# **Super Bowl Rematch: St. Louis Rams vs. Tennessee Titans**

**David Lochbaum**  
**Nuclear Safety Engineer**  
**December 4, 2000**

**SUBJECT: COMMENTS ON GENERIC AGING LESSONS LEARNED (GALL) REPORT**

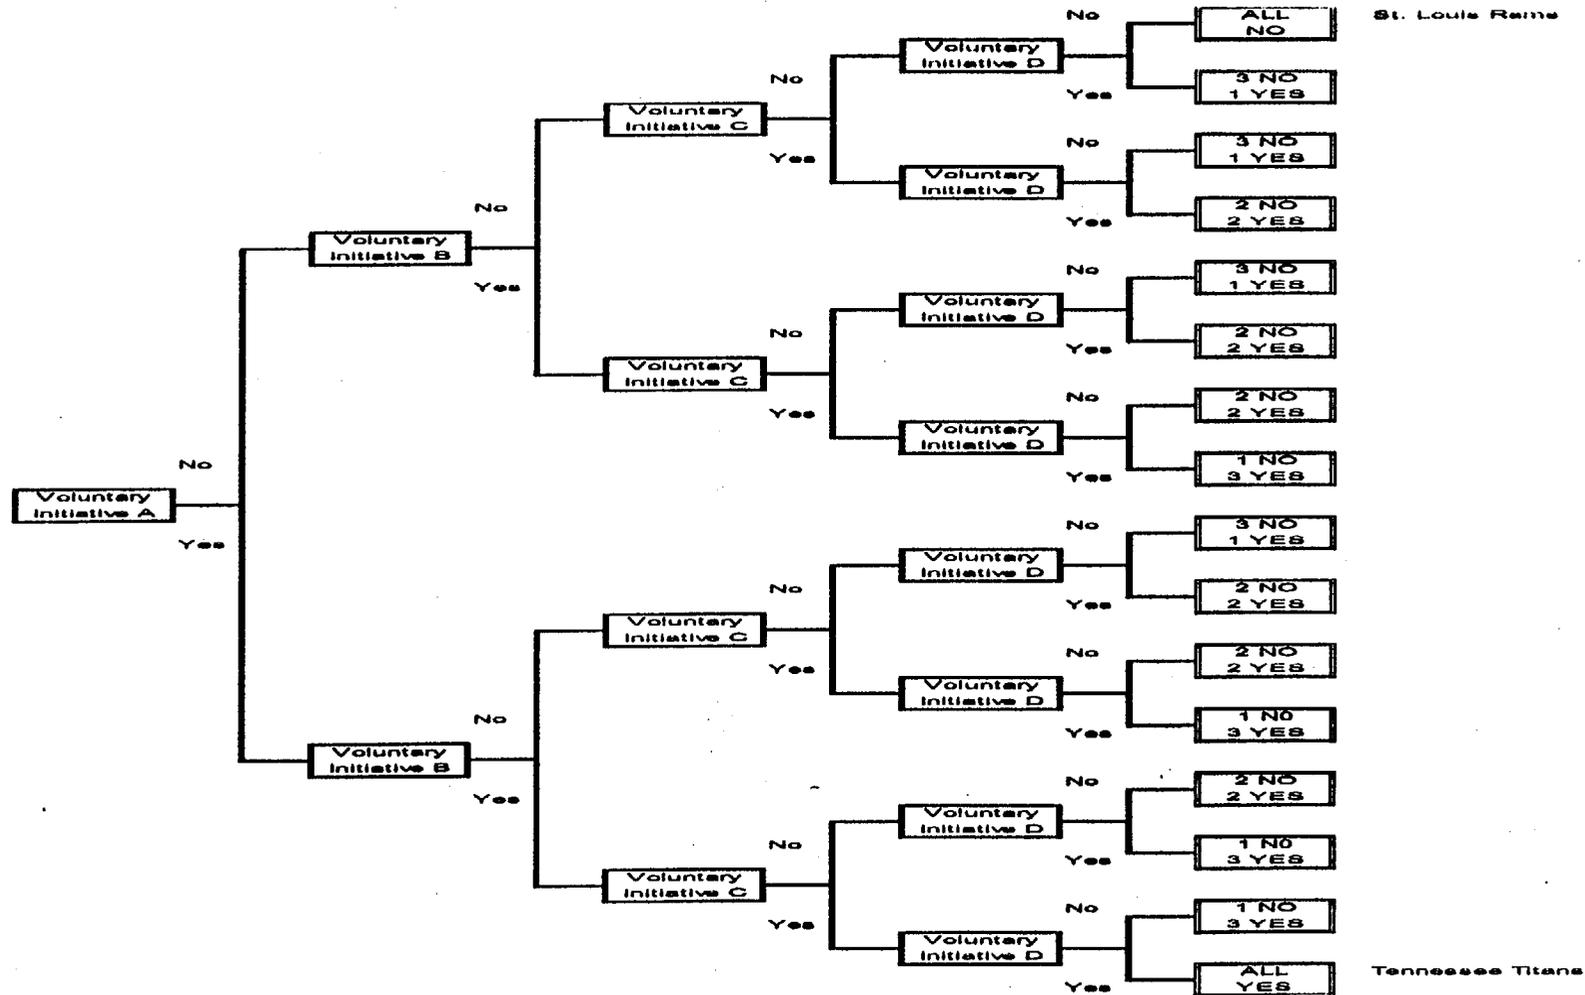
**Fact: NRC is developing GALL in parallel with several voluntary regulatory initiatives, such as risk-informed special treatment requirements.**

**Question: How does it all fit together?**

Because the voluntary regulatory initiatives are not mandatory, it is reasonable to assume that some plant owners will adopt all of the initiatives, some plant owners will adopt none, and some plant owners will adopt some of them. Figure 1 illustrates the potential dilemma for just four (4) voluntary regulatory initiatives. If the plant owners will be equally divided on every decision, sixteen (16) distinct regulatory schemes are produced. The real problem is even more mind-boggling because the agency is considering more than four (4) voluntary initiatives and plant owners also have the option of adopting them in any order (e.g., A-B-C-D, D-A-C, A-C-D, D-A-C-B, etc.).

Figure 1 also illustrates a specific concern about the intended use of the GALL report. That concern relates to the fidelity of all the voluntary regulatory initiatives. In other words, are all of the initiatives compatible and interchangeable? I attended the public workshop on GALL conducted by the NRC staff on September 25, 2000. Pointing out that the draft GALL report differentiated between aging management program requirements for safety and non-safety related components, I asked Mr. Christopher Grimes about the impact of a plant owner who has adopted the voluntary special treatment requirements initiative. Mr. Grimes conceded that the GALL report might have to be revised to accommodate that case. The questions that the NRC should answer before issuing the final GALL report, or approving the adoption of any voluntary initiative, include:

1. Is the GALL report rendered obsolete or invalid when a plant owner adopts a voluntary regulatory initiative (such as risk-informed special treatment requirements) before submitting the license renewal application?
2. Is a license renewal granted based upon the GALL report invalidated when that plant owner subsequently adopts a voluntary regulatory initiative?
3. Is the regulatory endpoint for a plant adopting voluntary initiative X before submitting a GALL-based license renewal application equivalent to that for a plant submitting a GALL-based license renewal application before adopting voluntary initiative X?
4. When the voluntary regulatory initiatives spawn a spectrum of regulatory schemes, as suggested by Figure 1, what does Generic mean?

- 
- ③ **Before issuing final GALL report or approving any voluntary regulatory initiative, the NRC must determine if all of the pieces fit together and will continue to fit together.**
